February 12, 2013

The Montana Environmental Trust Group, LLC, Trustee of the Montana Environmental Custodial Trust (the Custodial Trust), respectfully submits the attached, *"Former ASARCO East Helena Facility Interim Measures Work Plan—2013 (Final)"* (the IM Work Plan 2013) to the US Environmental Protection Agency (EPA), as Lead Agency for East Helena Site. The Final IM Work Plan 2013 was prepared in accordance with EPA's conditional approval letter of January 31, 2013 and the Custodial Trust's obligations under the Consent Decree and Environmental Settlement Agreement Regarding the Montana Sites and the First Modification to the 1998 Consent Decree (Civil Action No. CV 98-3-H-CCL, US Federal District Court, District of MT). The Final IM Work Plan 2013 is available in electronic form on the Custodial Trust website (<http://www.mtenvironmentaltrust.org/>).

Former ASARCO East Helena Facility Interim Measures Work Plan—2013

FIGURE 3-4
Water Level Elevations and
Streamflow Gain/Loss
Interim Measures Work Plan-2013
East Helena, Montana

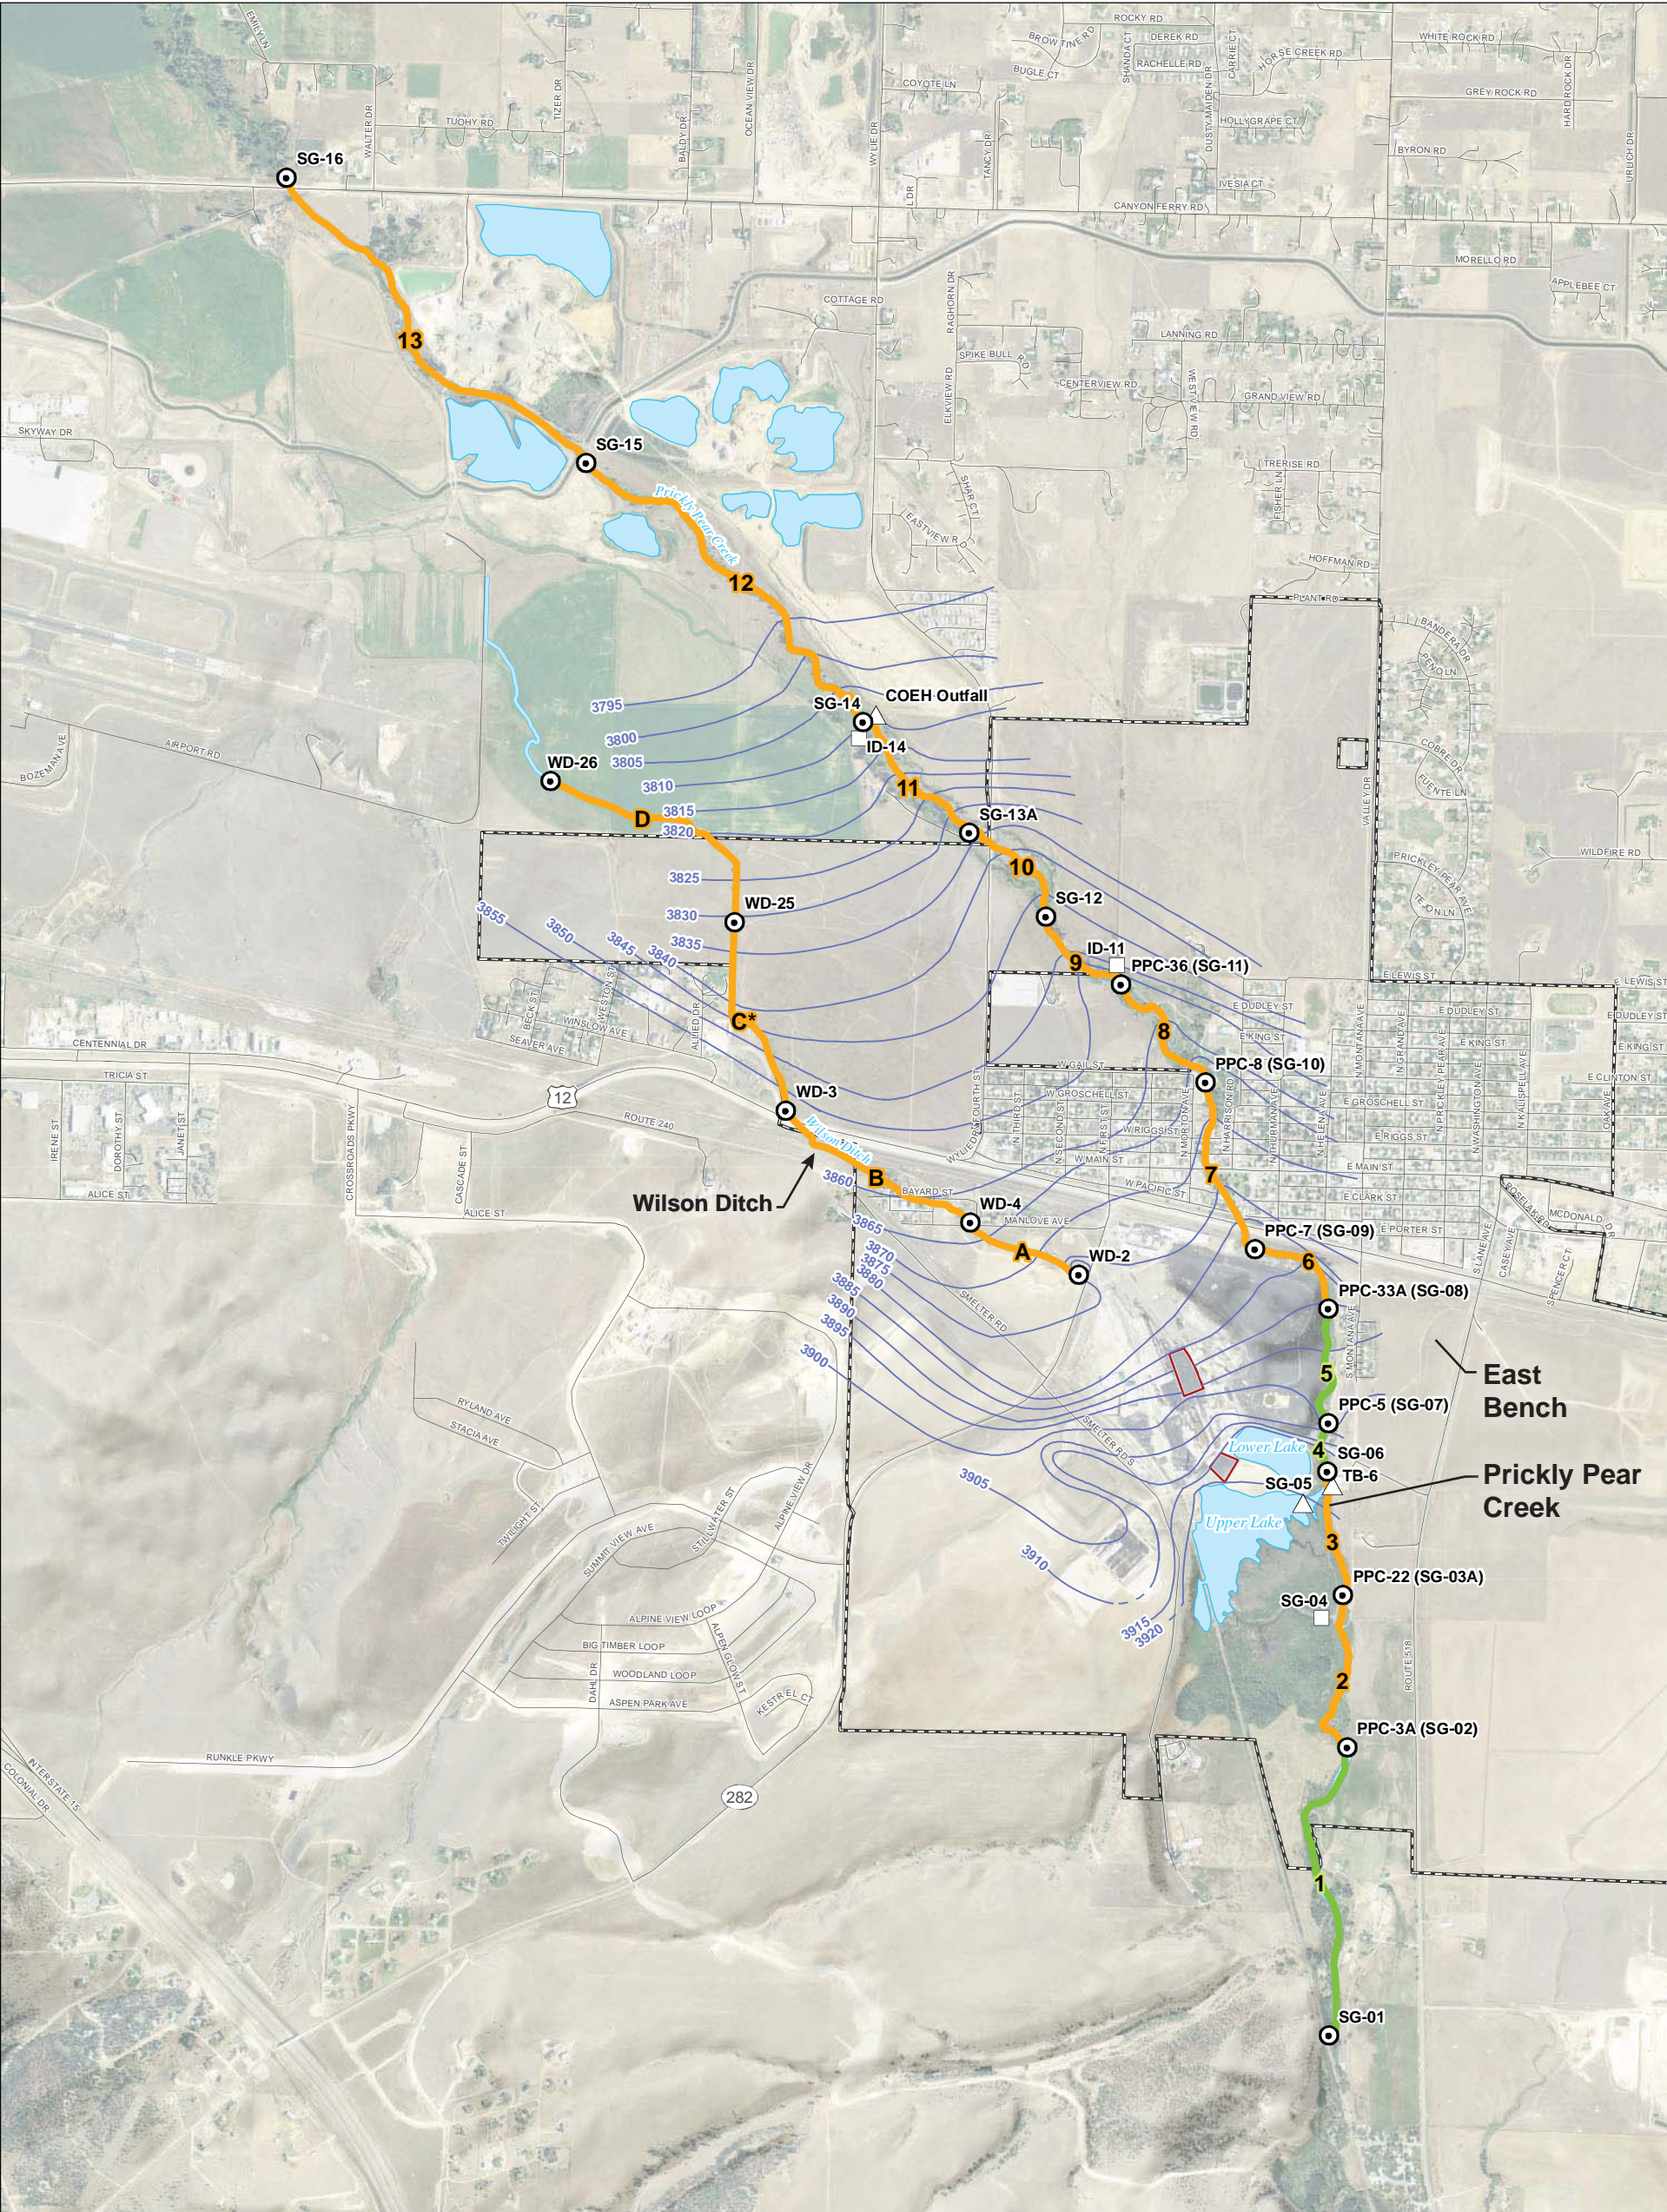
4. p 3-15, Figure 3-4. It would be useful to identify and separate the coarse grained primary aquifer from the fine-grained water bearing units in the volcanoclastic deposits immediately west of the site, which is technically a separate aquifer which discharges into the high permeability alluvial aquifer.

EPA Response: EPA notes that this information was presented in Figure 3-2 of the Interim Measures Work Plan 2012, which shows the geology of the Helena Valley.

Figure –Map from Stickney (2000) noting Helena Valley Active Faults and Earthquakes

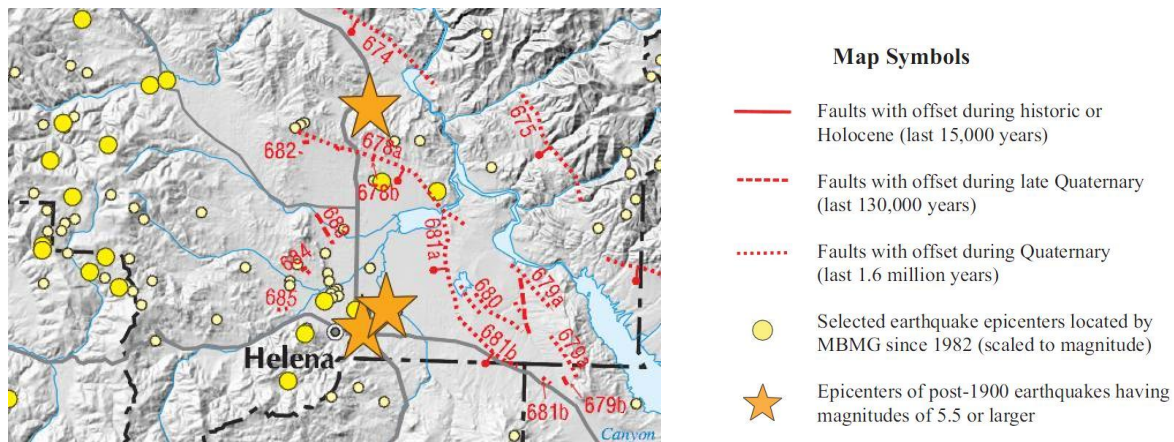
The discussion notes that the nearest active fault(s) are more than two miles away from the site based on Stickney (2000), and that the nearest known faults are more than 1.5 miles away. The use of this reference at the local scale is not appropriate since major earthquakes are noted in the Helena Valley since 1900, and a number of minor earthquakes since 1982 have been identified. While this map does not identify the active faults for these earthquakes, they may be inferred from the geologic map by Mitchell included with the USGS report on Helena Area Bedrock Aquifers by Thamke (2000). The discussion in this section is inconsistent with the discussion in Section 3.1.2 which notes that the southern end of the Helena Valley is “defined by a series of major seismically active faults, including one inferred to be approximately 1,500 feet north” of the site. The discussion between the two sections should be consistent.

EPA Response: EPA is requesting that the Custodial Trust correct this discrepancy in the revised 2013 Work Plan. EPA is also considering the value of this information to the proposed interim measures. If it does not add significant value, then EPA will request that the Trust shorten the discussion in addition to ensuring that the information is correct.
